STAFF RECOMMENDATION

NCPC File No. 6725

JOHN MARSHALL MEMORIAL PARK

January 25, 2007

PROPOSED SITE PLAN

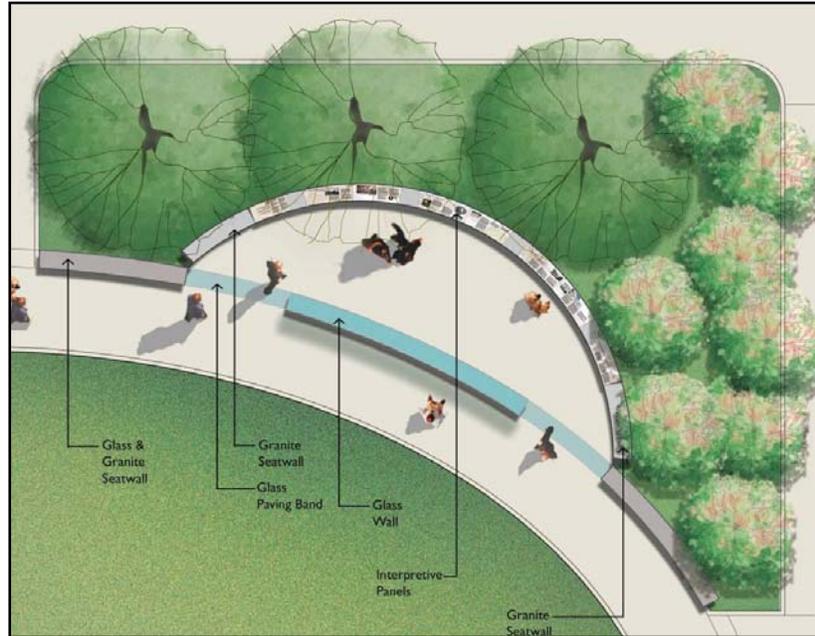
Staff supports the overall concept design, including three-tiered plan, central ellipse, relocation of the John Marshall Statue, re-design of trees and planting, and restoration of fountains and plaza elements at the north and south ends of the park. There are a several items, however, that staff recommends the design team explore further when preparing preliminary and final site development plans. Staff advocates that refinements to the design respect the original intent of the park and place primary emphasis on the prominence of the John Marshall statue as the main interpretive element, as well as the overall landscape design.

PROPOSED INTERPRETIVE ROOM

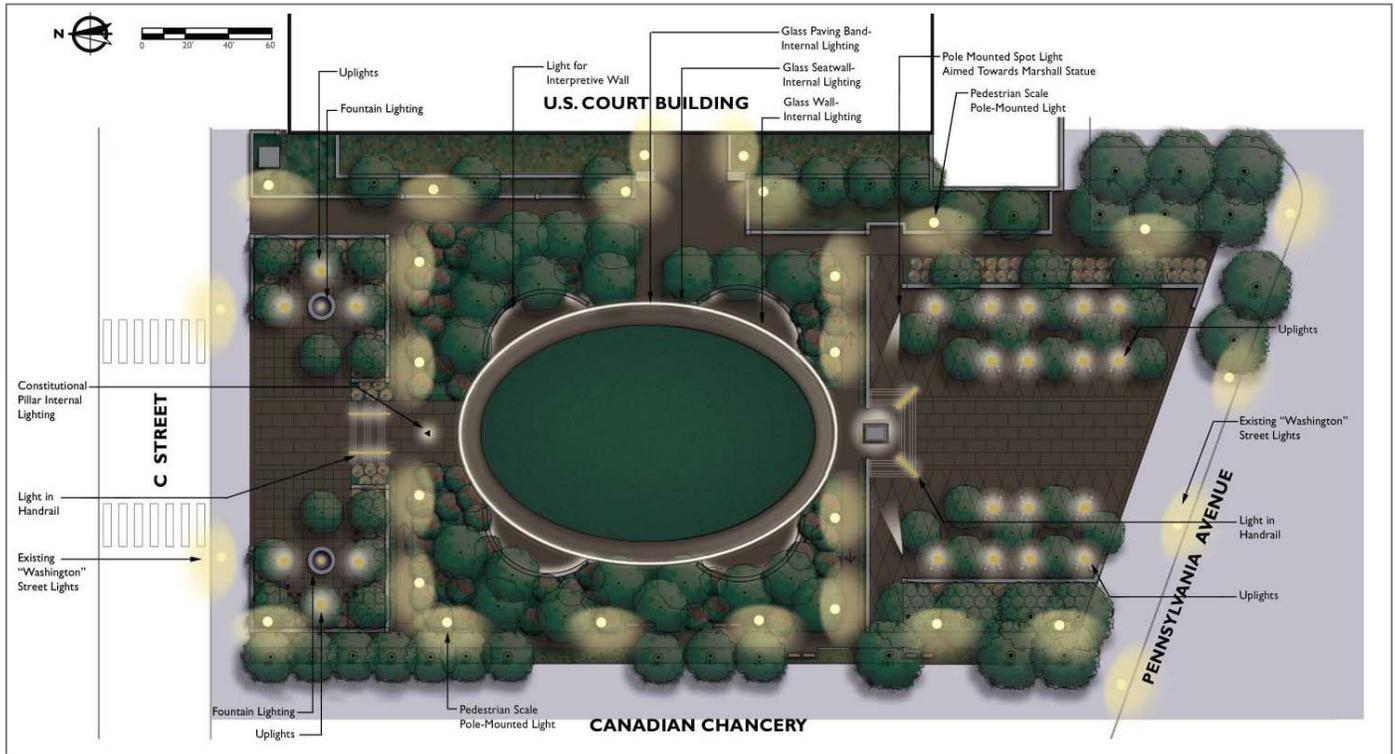
- While staff supports the goal of informing the public of John Marshall's legacy, the interpretive panels are extensive and contain an amount of interpretive text unprecedented at similar sites in D.C.; the effect is the creation of an outdoor museum. Staff recommends reducing the quantity and detail of text, instead placing more inspirational and broad concepts and facts in a way that is more integral (or even secondary) to the overall landscape design.
